To: Chairman and Members, Nelson County Planning Commission

From: Tim Padalino | Director | Department of Planning & Zoning

Subject: Class III Tower Permit Application #2013-007 (Ms. Cheryl L. Taylor / AT&T)
(postponed and continued from December meeting at applicant's request)

Green Infrastructure Map

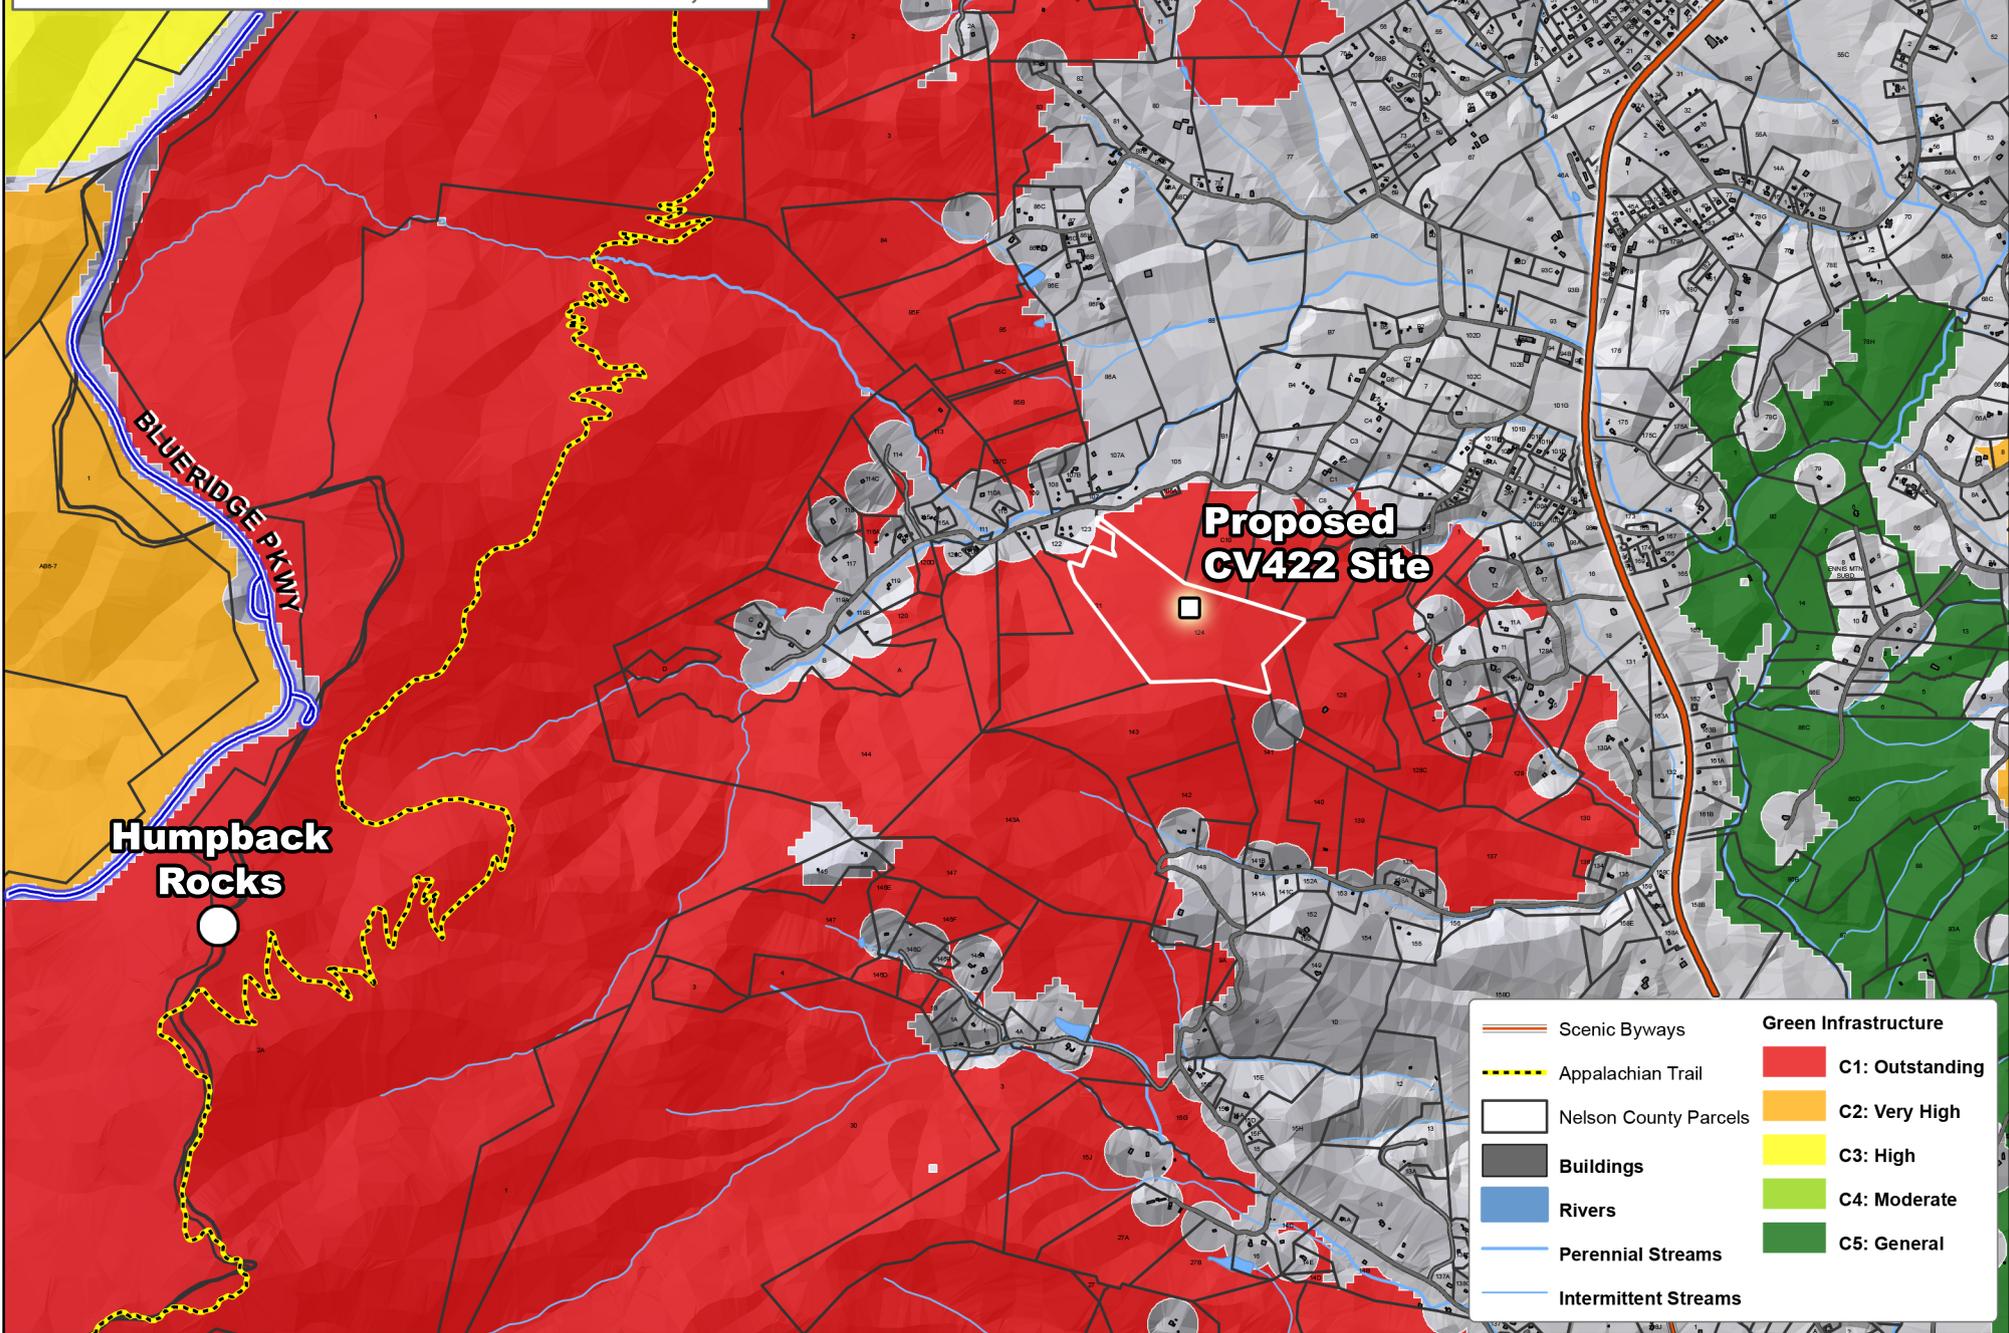
1. The site is in located in an interior forest of mixed hardwoods. Please refer to Factor A, Notes 2 and 3 for additional details.
2. The site is located in an area of highest level of (statewide) environmental importance, as defined by the Virginia Dept. of Conservation and Recreation (DCR), and as shown in the attached Green Infrastructure Map. Specifically, DCR has classified this location as a "core habitat" of "Outstanding Ecological Integrity," which is DCR's highest possible ranking.

- i. DCR's "Natural Heritage Program" created the statewide Virginia Natural Landscape Assessment (VaNLA) tool, which is a landscape-scale GIS analysis that has identified, prioritized, and linked important landscapes and habitat throughout Virginia. VaNLA identified large, unfragmented cores, which are patches of natural land with at least 100 acres of interior cover. To assess their unique values, each core has been assigned an "Ecological Integrity" score that rates the relative contribution of that area to the ecosystem service values, such as cleaning our air, filtering our water, providing habitat for animals and plants, and providing wild sources of foods, materials, and medicinal compounds.
